NOTICE 01-002

It has come to the attention of the Foundation that there are check valves not approved by the Foundation, which may be installed in the following Ames Company and Watts Regulator Company backflow prevention assemblies:

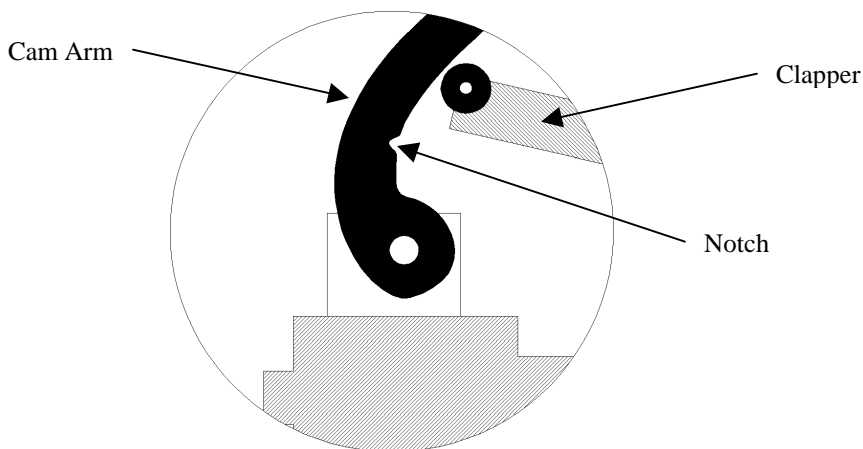
The subject check valves contain a notched cam arm as illustrated below:

This check valve design is intended for use in the Ames 2-1/2", 3", & 4" Model 2000SS **F** and 3000SS **F**. These models maintain listings by another listing/approval agency(s), but these models have not been evaluated or approved by the Foundation.

The Ames (Watts) Model 2000SS (774), 2000SE (774X), 3000SS (774DCDA), and 3000SE (774XDCDA), 4000SS (994) assemblies containing the notched cam arm check valve(s) are not approved by the Foundation.

Should you have an assembly affected by this situation, please contact the Technical Service Departments at Ames (530) 666-2495 or Watts (978) 689-6066 for Foundation Approved replacement components.
